## UNITED STATES PATENT AND TRADEMARK OFFICE

APPLICATION NO.	FILING DATE	FIRST NAMED INVENTOR	ATTORNEY DOCKET NO.	CONFIRMATION NO.		
10/016,174 10/30/2001		Edmund L. Wolak	P1292D1	1851		
22849 75	590 07/18/2002					
SCOTT W HEWETT 400 WEST THIRD STREET #223			EXAM	EXAMINER		
			LEUNG, QUYEN PHAN			
SANTA ROSA, CA 95401			ART UNIT	PAPER NUMBER		
			2828			
		DATE MAILED: 07/18/2002

#### **DETAILED ACTION**

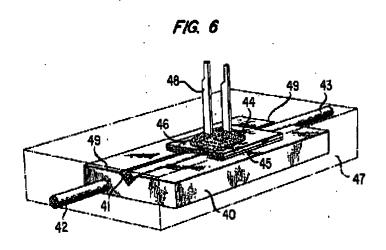
- (b) the invention was patented or described in a printed publication in this or a foreign country or in public use or on sale in this country, more than one year prior to the date of application for patent in the United States.
- 2. Claims 33-39 are rejected under 35 U.S.C. 102(b) as being anticipated by Di Domenico, Jr et al (4,165,496). Di Domenico, Jr et al discloses the claimed invention. For example, Figure 1 illustrates a laser module comprising a laser diode (35) having a

front facet, an optical fiber (11) having a fiber end (13) disposed proximate to the front facet to couple light emitted from the front facet to the optical fiber (11), the front facet and the fiber end (13) forming a coupling region there between and a monitor photo

diode (15) disposed to couple light from at least one of the fiber end (13) and the front facet.

Regarding the reflectance-increasing coating on the fiber end (13), note col. 3 lines 28-32.

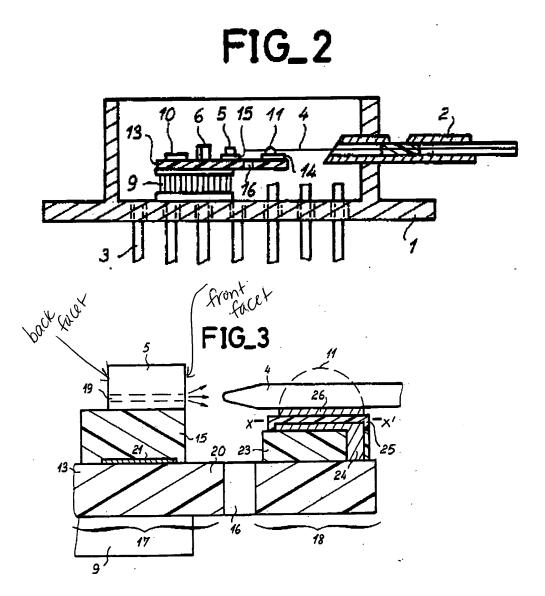
Regarding the substrate to which the laser diode and the optical fiber are mechanically coupled, note figure 6, element 40 and col. 5 lines 30-58. Note further the

submount (47) for mechanically coupling the substrate (40) to the laser diode and optical fiber.

Fig. 2

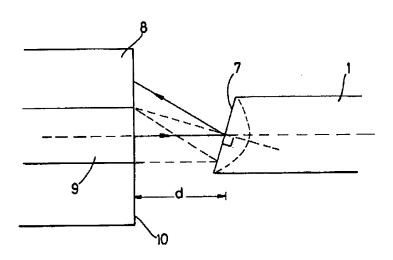
4. Claims 42-44 are rejected under 35 U.S.C. 103(a) as being unpatentable over Tournereau et al (4,807,956) in view of Harker (5,940,557). Tournereau et al discloses the claimed invention except for explicitly teaching a lens edge that is not perpendicular to the center axis of the optical fiber. Note figures 2 and 3 a laser diode source (5)

having a laser cavity between a front facet and back facet; an optical fiber (4) having lensed fiber input end disposed proximate to the front facet of the laser diode source (5)

to receive a first light output from the front facet; and a laser monitor disposed proximate to the back facet of the laser diode source (5) to receive a second light output from the back facet, the second light output including amplified back-reflected light.

# Fig. 5

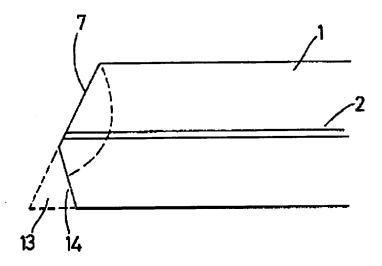
As shown in figures 1-5 and discussed in col. 4 lines 23-29, Harker teaches a

lens edge that is not perpendicular to the center axis of the optical fiber, for the advantageous benefit of minimizing the disturbing of operation of the laser diode. It would have been obvious to one of ordinary skill in the art to modify Tournereau et al by employing a lens edge that is not perpendicular to the center axis of the optical fiber, as taught by Harker et al, for the advantageous benefit of minimizing the disturbing of operation of the laser diode.
